Art Haus

469-483 BALMAIN ROAD

Supplementary Submission

Revised Concept - Summary of Changes

Revised Setbacks and Building Separation

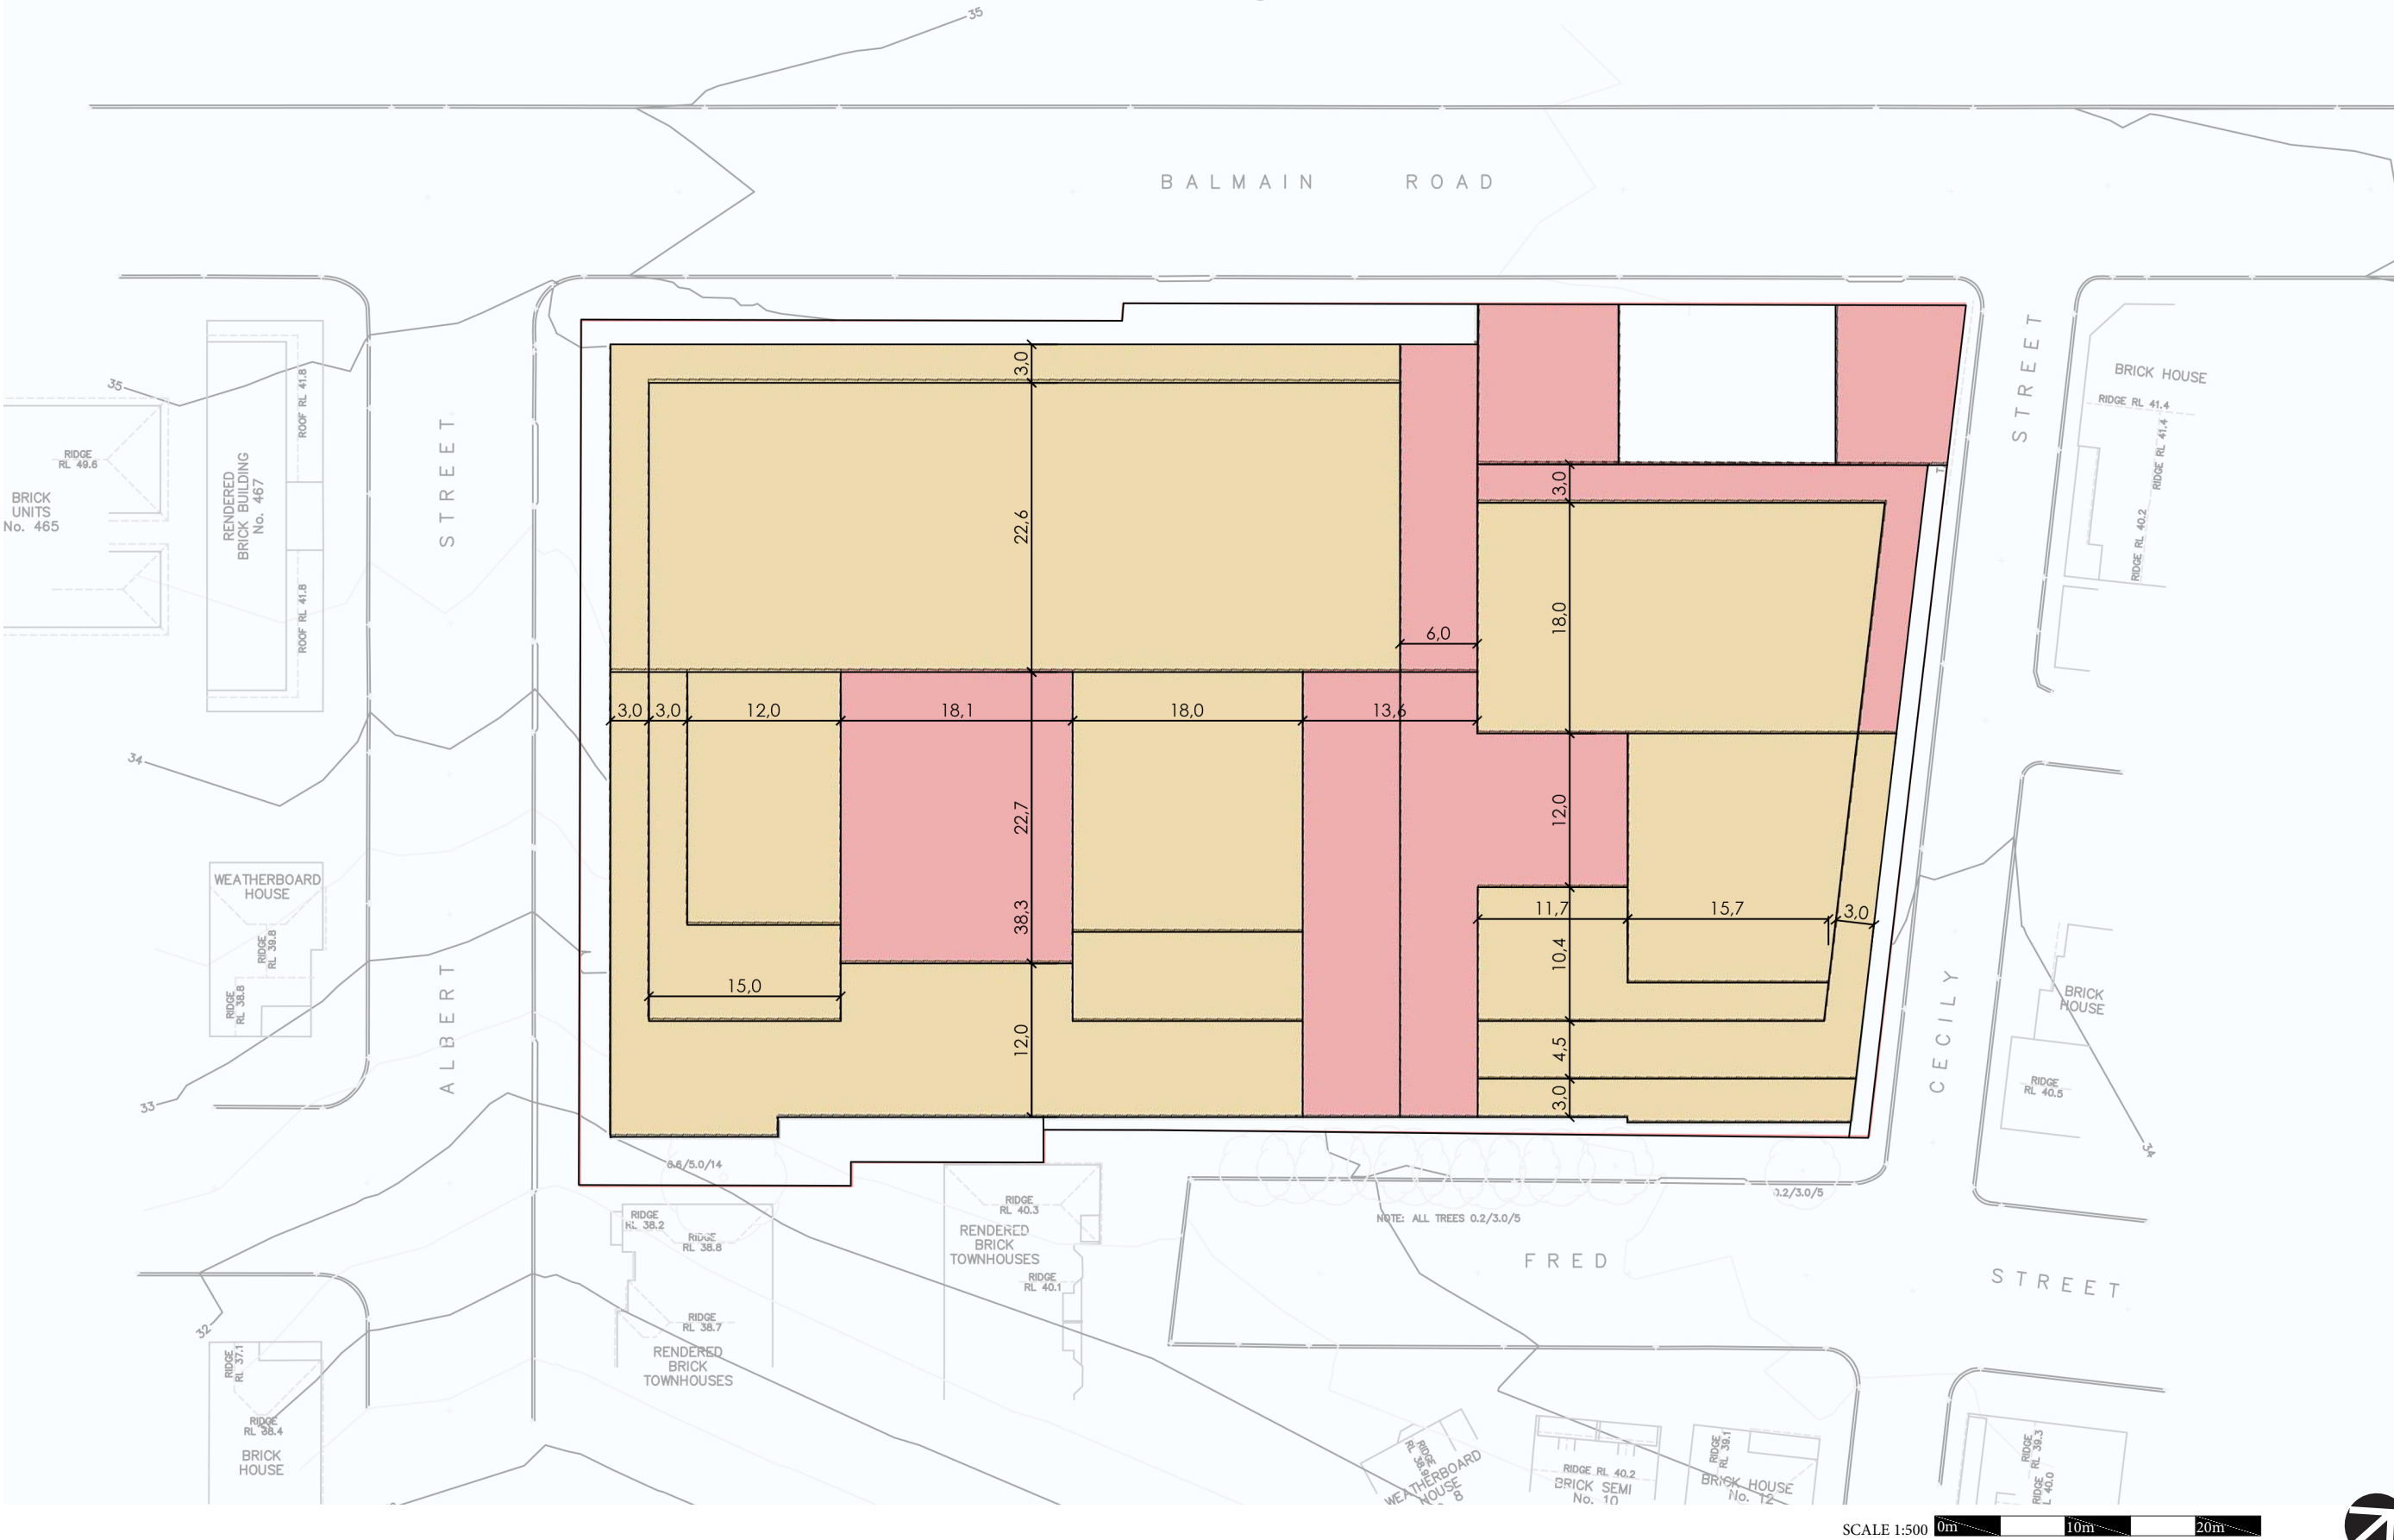
Council request	Design response
Council will consider additional controls for the site such as a minimum residential setback from the eastern boundary in light of the sites interface with other industrial uses.	There are no existing, adjoining land uses to the east that would result in a land use conflict. But, the revised Proposal does provide appropriate horizontal and vertical setbacks to avoid any future conflicts.
The residential component adjacent to the heritage character buildings should be setback further so that the six storey component is not directly adjacent to these buildings to ensure the heritage integrity of these buildings is retained.	It is noted the retained character buildings are not classified as 'heritage'. Notwithstanding, based on Council's advice the residential component has been setback an additional 3m from the retained character buildings.
